EXTRACT FROM COUNCIL MEETING MINUTES OF MAY 17, 2016

OFFICIAL PLAN AMENDMENT FILE OP.11.003 ZONING BY-LAW AMENDMENT FILE Z.11.009 77 WOODSTREAM INC. WARD 2 - VICINITY OF REGIONAL ROAD 7 AND WOODSTREAM BOULEVARD

RE: 77 & 87 Woodstream Blvd

OP.11.003 and Z.11.009 77 Woodstream Inc.

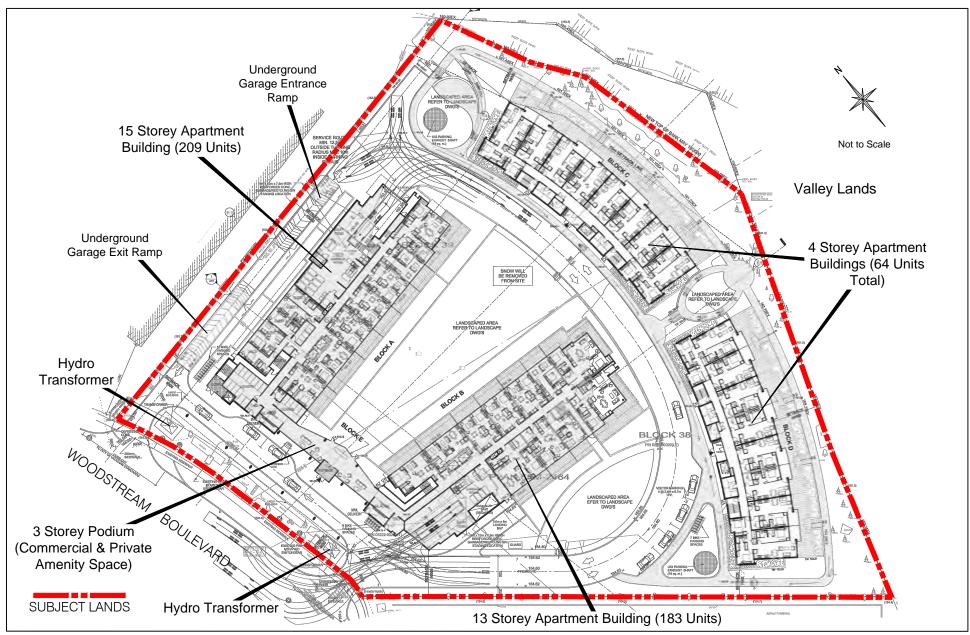
- The proposed driveway location is too close to our client's driveway. Currently, the driveways servicing 87 & 93 Woodstream Blvd are separated by approximately 10m of landscaping. This has functioned effectively to date as the major times of use are different for the Industrial condominium and the banquet hall. The residential development proposes to move the primary entrance driveway closer to our client's driveway. This has the potential to create significant conflicts in the morning and evening rush hour periods as the major travel times would now be the same for both sites, albeit in opposite directions.

- The southern tower is too close to our client's lands. The southern tower is indicated
 as being 10m from the property boundary. Official Plan policies for High-Rise Buildings
 suggest that a building separation of 15m is required from any property line. This plan
 does not respect this requirement.

- The proximity of the southern tower could prejudice the future development of our client's lands. Should our client's lands develop in the future for High-Rise Residential uses, Official Plan policies suggest that a building separation between two towers on the two lots should be a minimum of 30m. Thus, the proposed development should provide for a minimum 15m setback from the property line to permit the efficient development of our client's lands.
